# Improved Technical Specifications

## LaSalle County Station

Volume 2:  
Sections 3.1 and 3.2

Figure 3.1.5-1

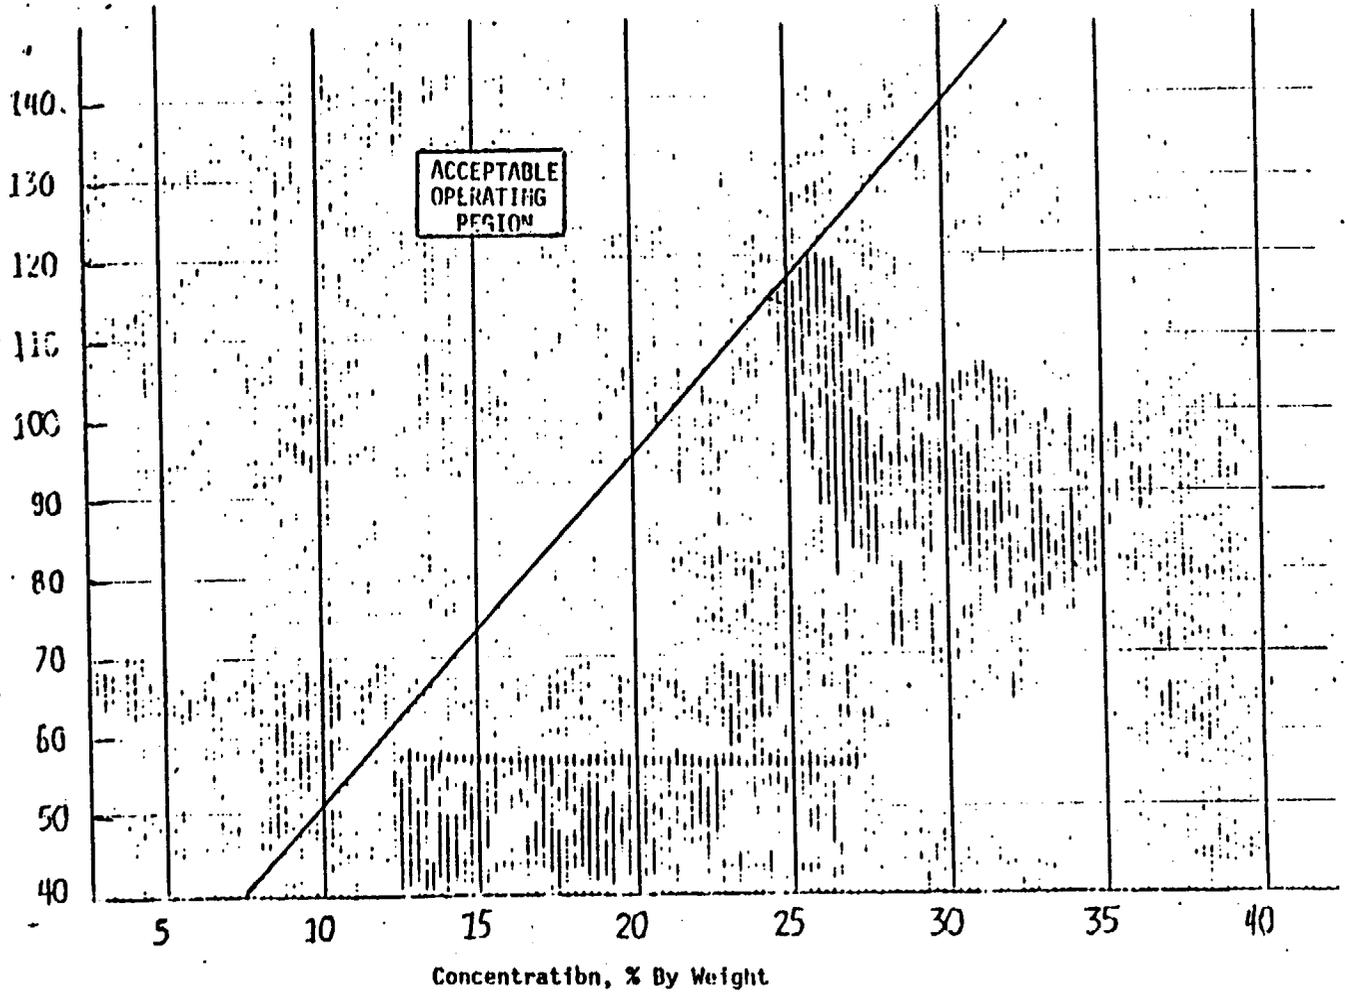
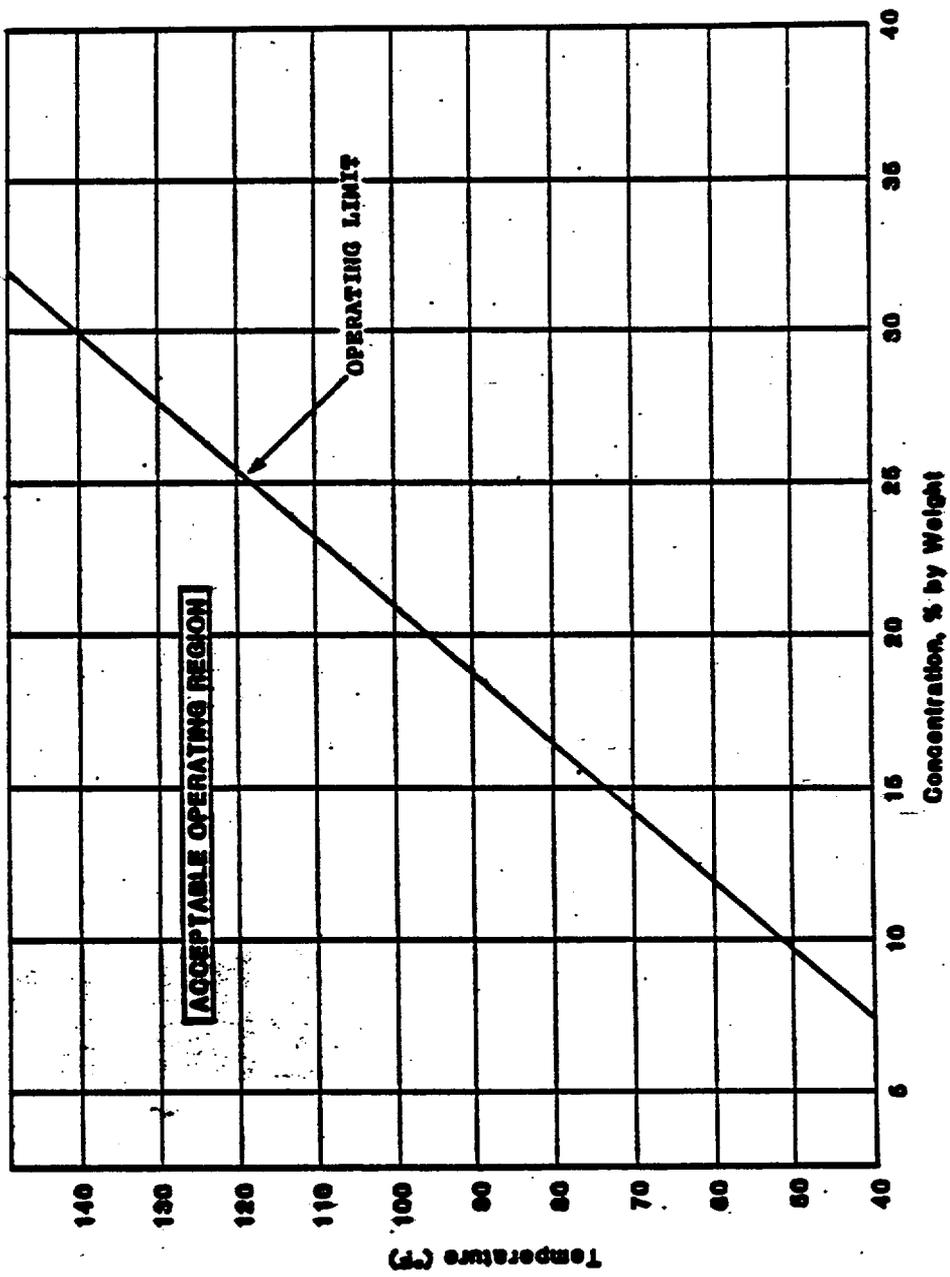
Figure 3.1.7-2

Figure 3.1.5-2

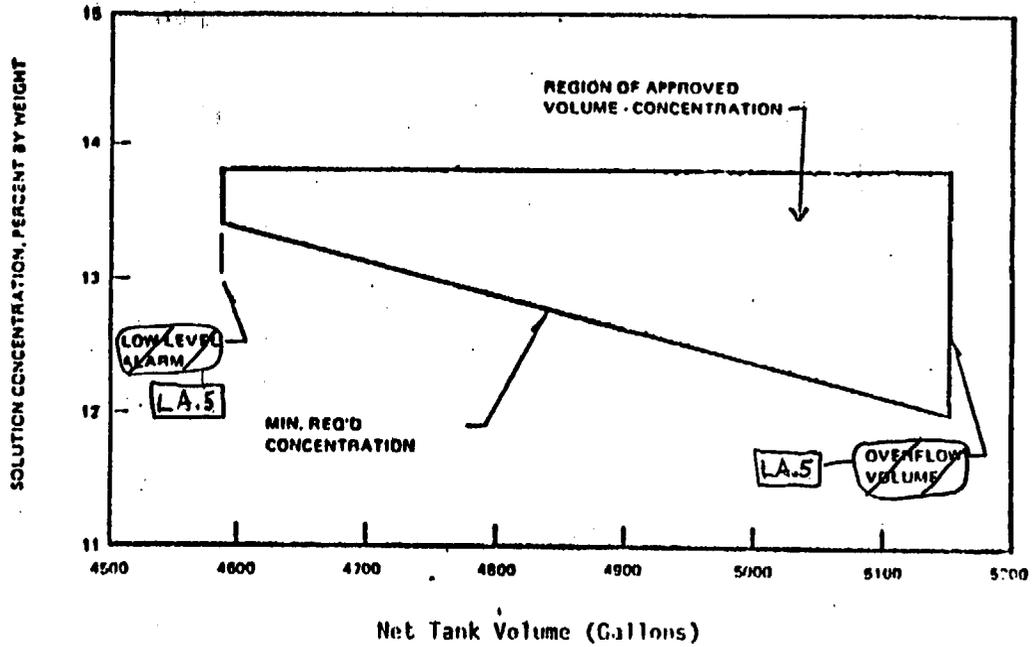
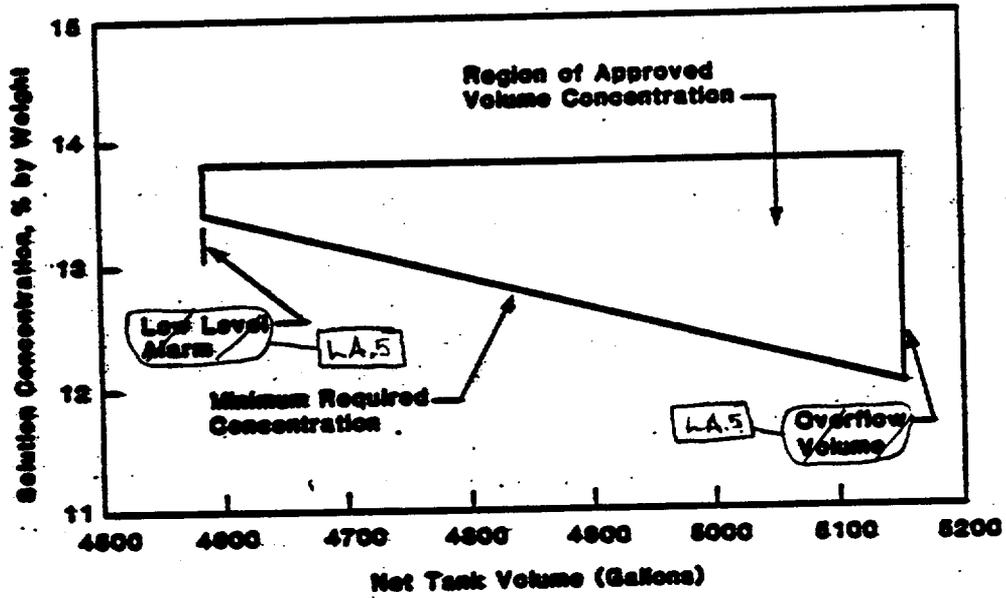
Figure 3.1.7-1
